FLAP BONDLINE INSPECTION

AA5-0600 thru AA5-0834, AA5A-0001 thru AA5A-0013, AA5A-0015 thru AA5A-0017, AA5B-0001 thru AA5B-0118, AA5B-0120, AA5B-0123, AA5B-0124 and AA5B-0132.

SERVICE LETTER NO. 75-8 Page 3 of 3

Figure 1. Flap Bondline Inspection

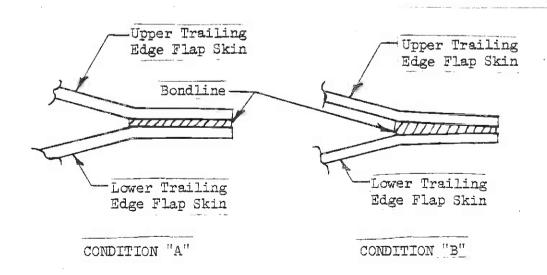
Field reports indicate that on some of the above aircraft serials affected, the flap trailing edge may be susceptible to partial bondline separation, if the upper and lower flap skins are not parallel in the area of the bondline.

View the inboard and outboard edges of both flaps. If inspection shows condition "A"; i.e., upper and lower trailing edge flap skins are parallel, no further action is required. If inspection shows condition "B"; i.e., upper and lower trailing edge flap skins are not parallel, perform the inspection steps listed below:

- 1. Carefully scan the flap trailing edge in a well lighted hangar or outside in daylight to determine the existence of hairline cracks between the two layers of bonded metal. Identify the location of any cracks with a grease pencil.

- 2. Gently tap the bondline with a coin or similar metal object to verify the existence of a bondline separation. Slowly move along the bondline, while tapping, and listen for a change in tone as the suspect area is traversed. A bondline separation will produce a flat or hollow sound when "tapped" directly in the damaged area.

- 3. If the results are questionable, attempt to insert a .004" to .006" feeler gauge into the bondline to verify that a separation exists.
- 4. If the results of inspection steps "2" and "3" are negative, install two (2) NAS1097-AD3-2 Rivets in each affected flap as shown in Figure 2. If the results of either "2" or "3" are positive, order Service Kit No. SK-125 and make the repairs accordingly.
